La Jolla Pointe Addition
ROCKWALL, TEXAS

GRADING PLAN

SHEET
C-11
OF **25**

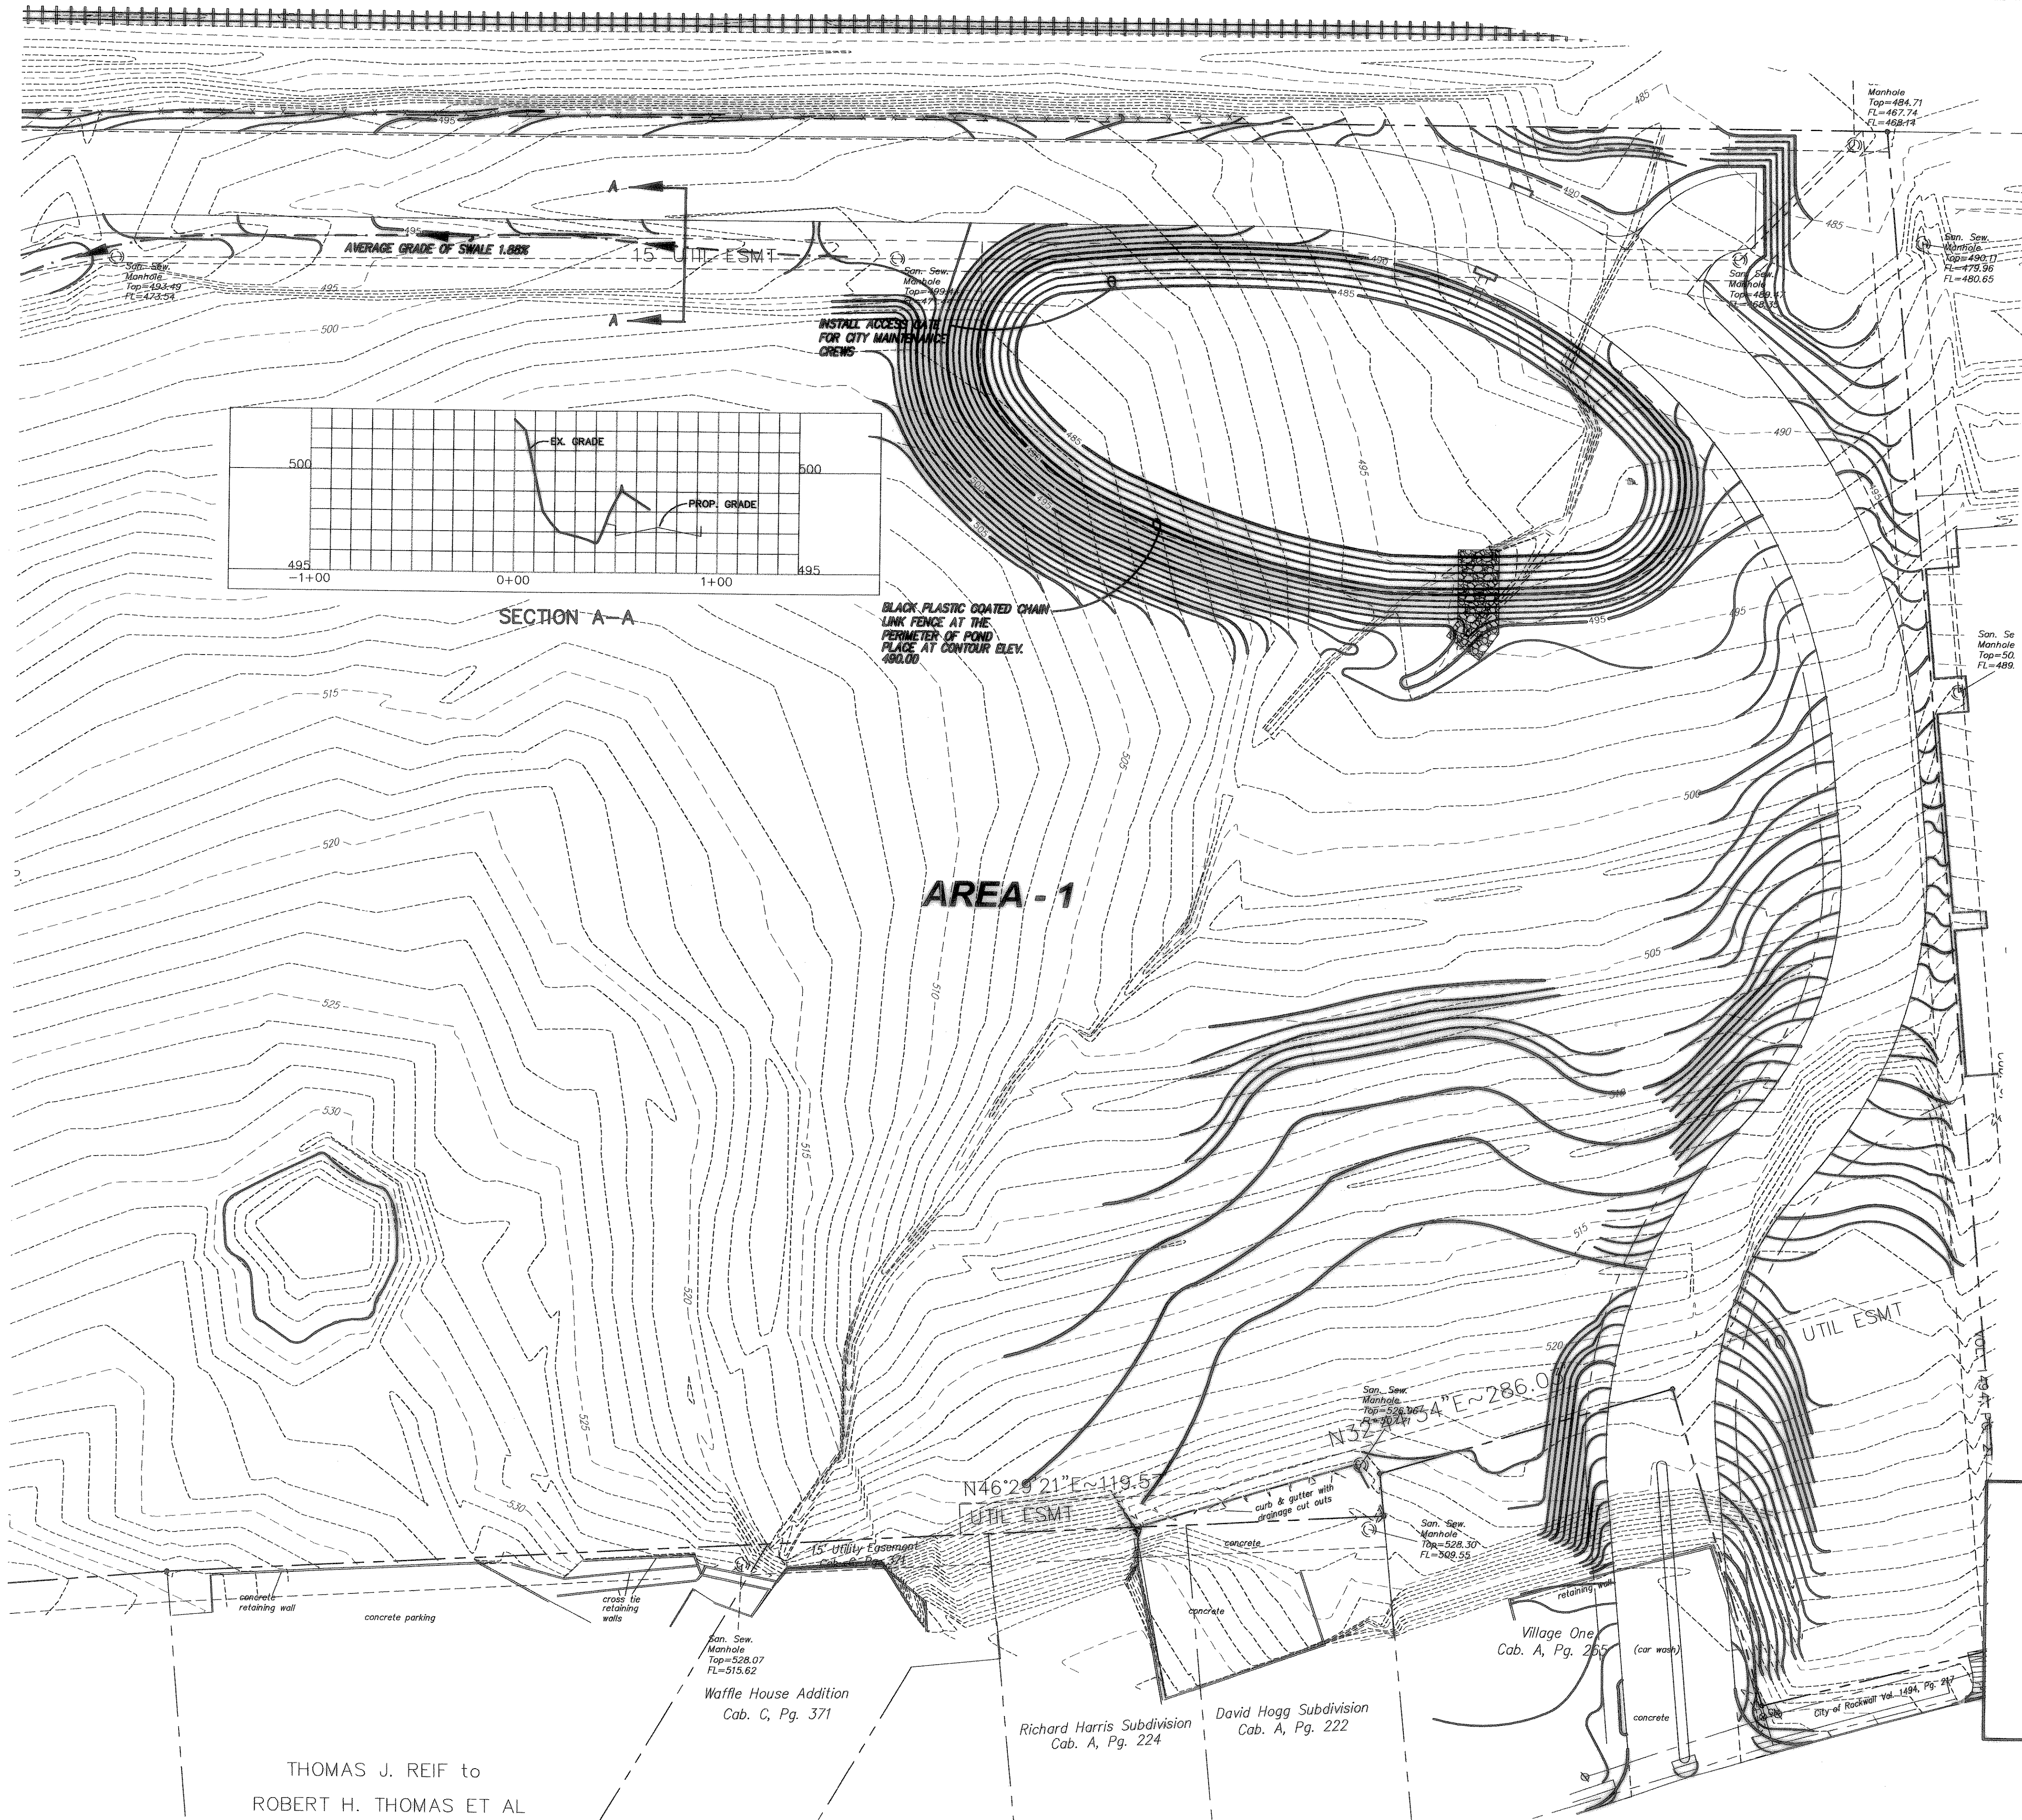
10c - spell check
